## OSSF Inspection Sheet

### **Permit of Authorization to Construct an On-Site Sewage Facility Permit Valid For One Year From Date Issued**

Permit Number: 118393  
Issued This Date: 03/20/2025  
This permit is hereby given to: W. Kelly Vandever Revocable Trust

130 CARTAMA  
SPRING BRANCH, TX 78070

# PVC PAN LINER DETAILS

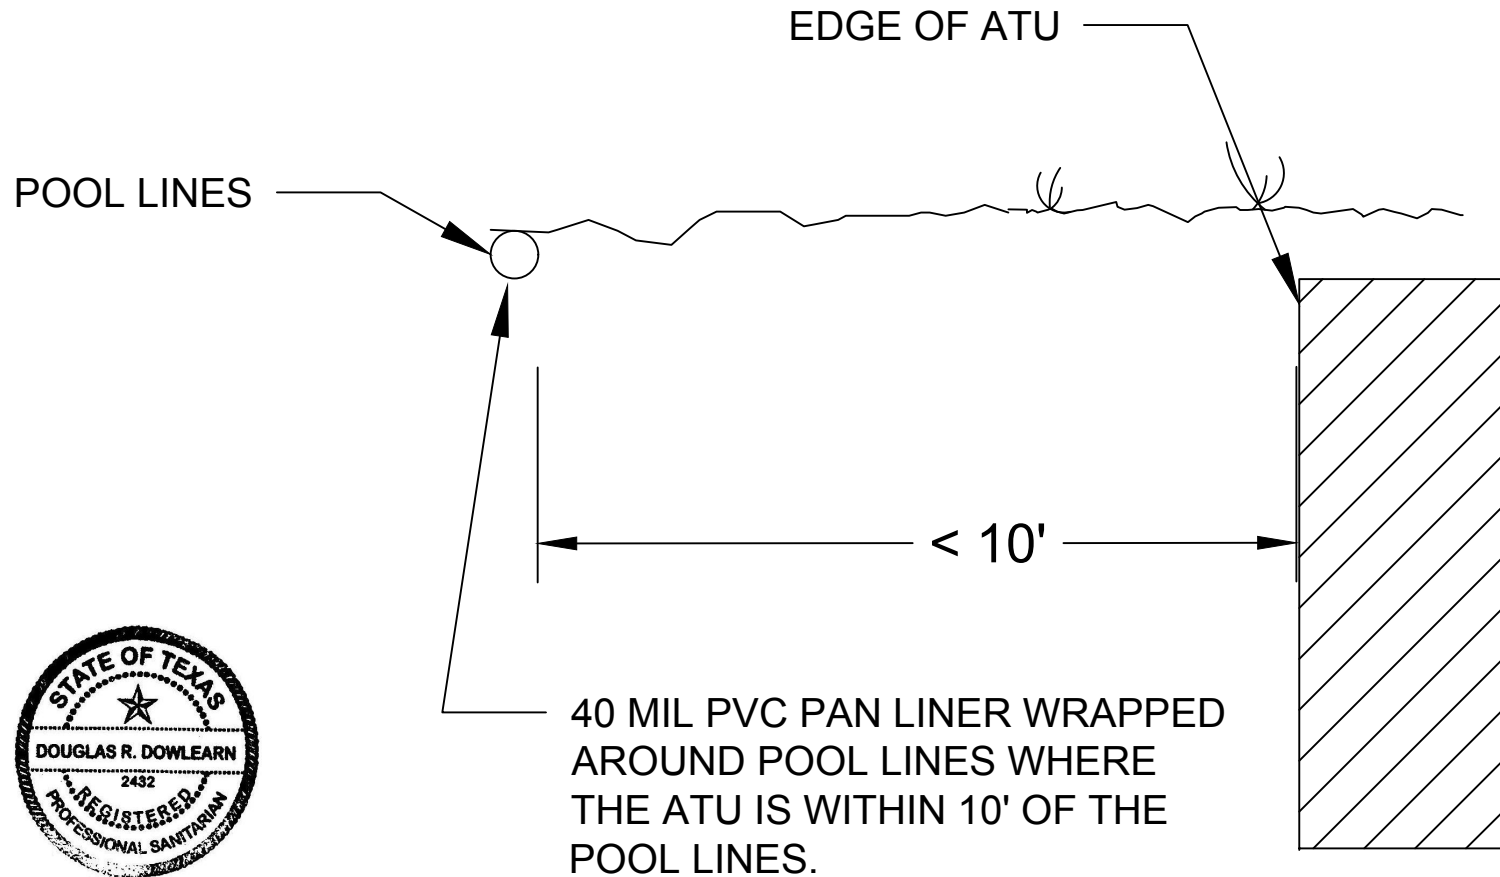
Provide a profile detail of how this will be installed and details of the 40 mil pvc pan liner.

A 40 mil PVC pan liner will be wrapped around the pool lines where the aerobic treatment unit is within 10' of the pool lines. In the event that the aerobic treatment unit and water line(s) is compromised, the liner will prevent effluent from the tank from flowing into the water line; therefore, the water line will not be contaminated.
